**Director's Report**

Project Name: Lakepointe  
 Description: Final site plan and PDA re-approval  
 Date on Agenda this packet pertains to: August 15, 2024

**RE: Lake Pointe – Final Site Plan and Final Engineering Plan –7<sup>th</sup> Review**

**RE: Lake Pointe – Final Site Plan Backcheck #4  
Parcel Number 12-36-177-003**

**FRONT ELEVATION**  
 SCALE: 1/4"=1'-0"

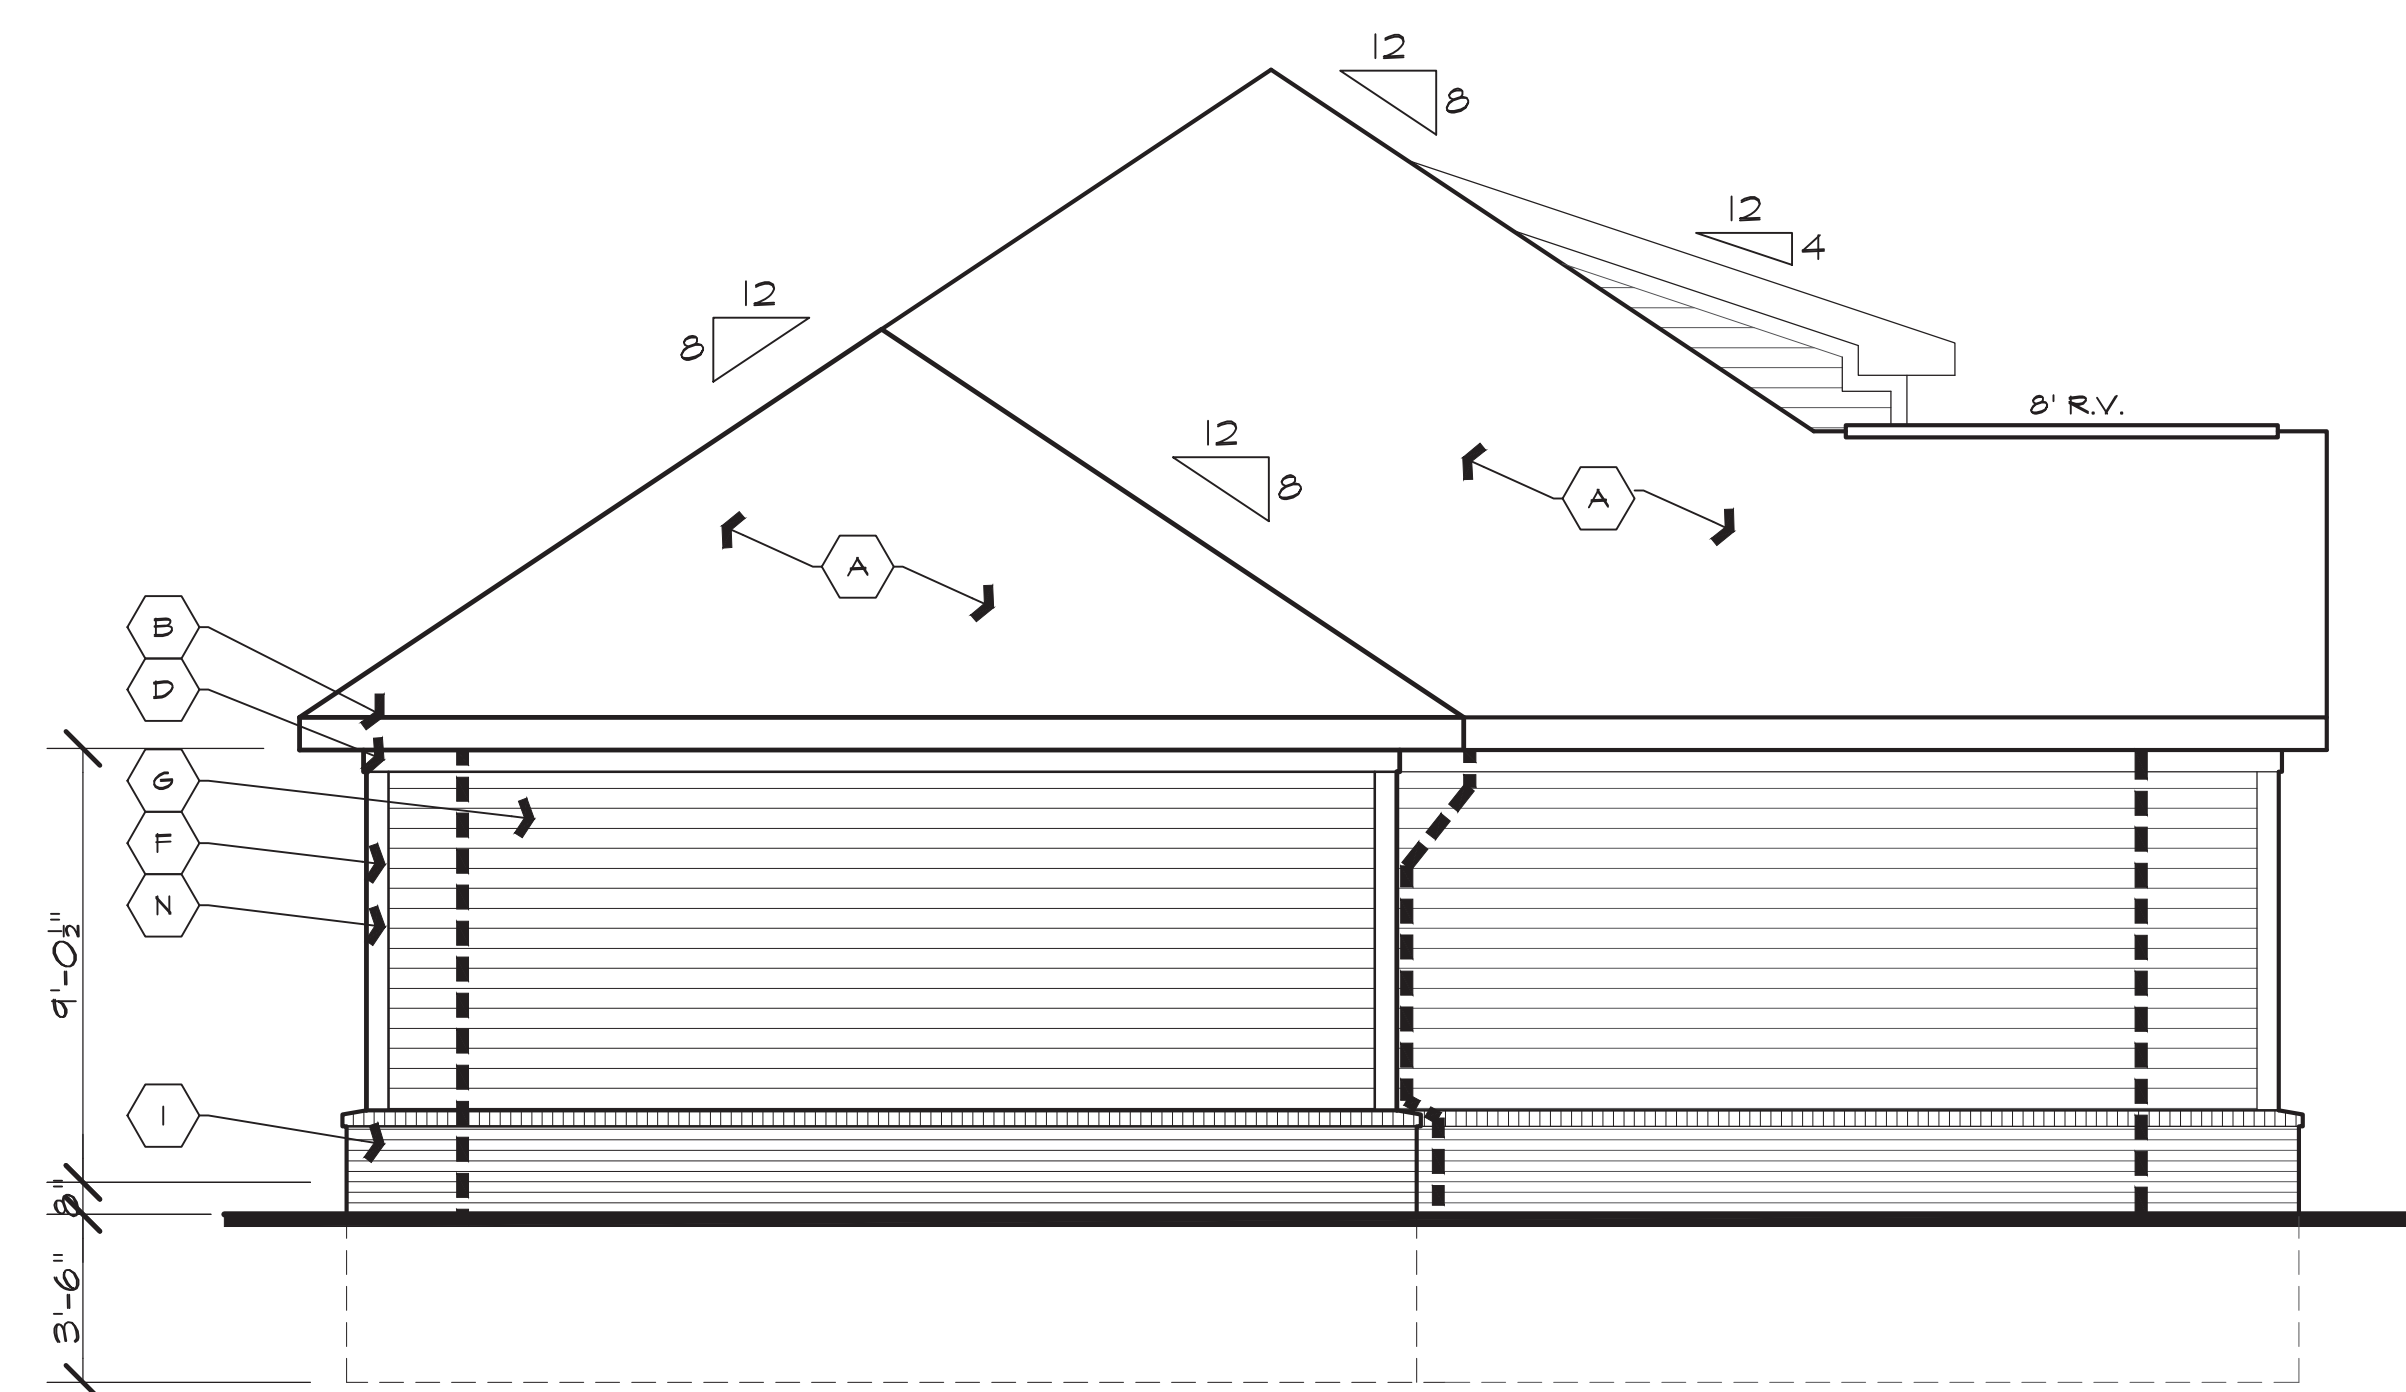
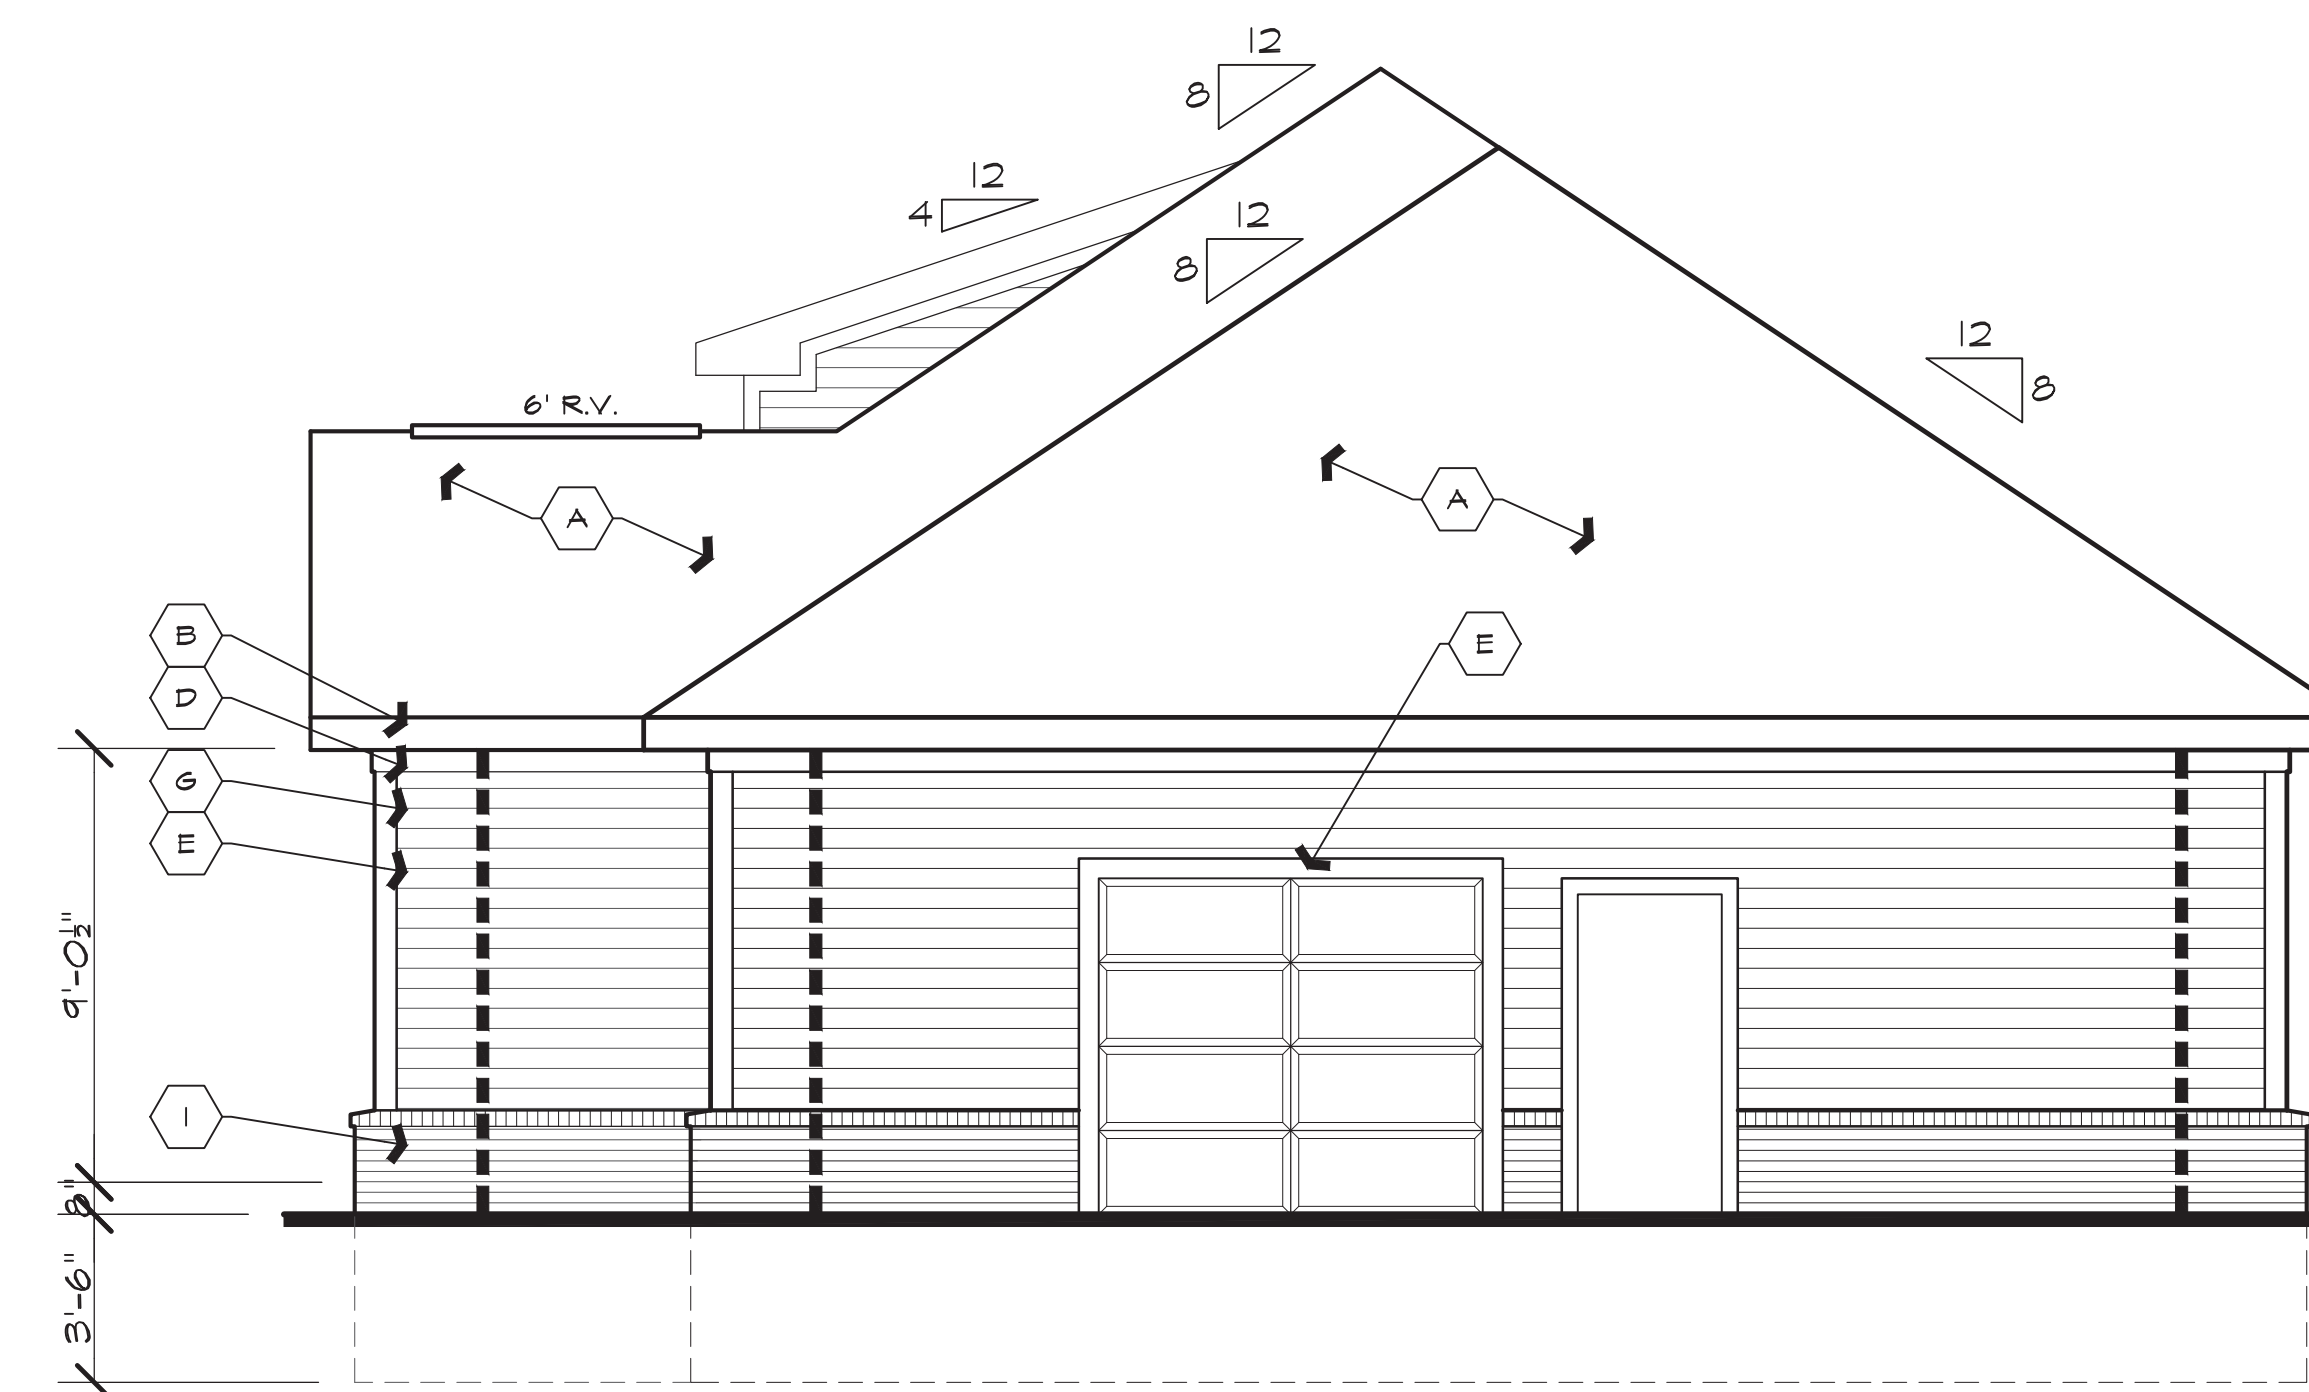
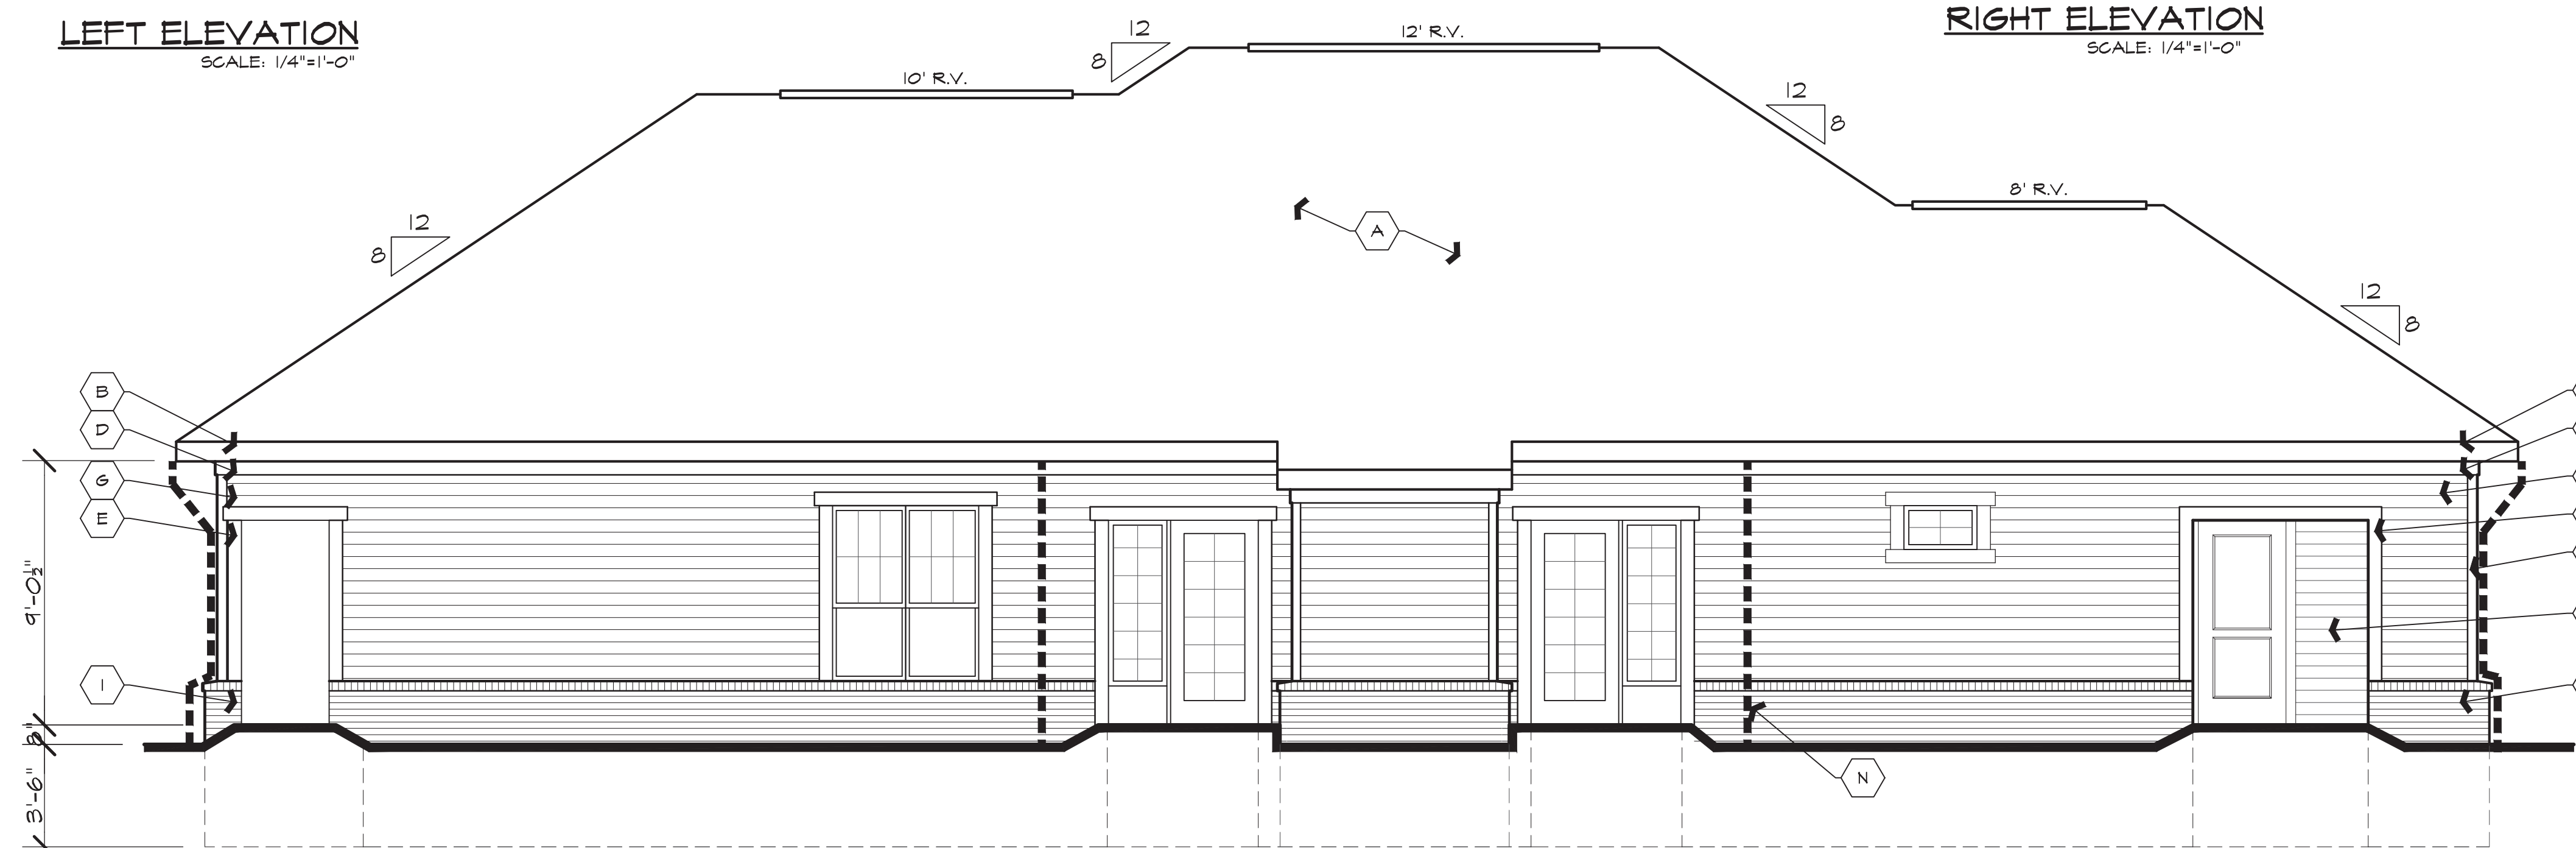
- As stated in previous correspondence (dated February 22, 2021), **elevations and building material details shall be provided for the clubhouse building.** (Comment addressed. Community building elevations have been provided).
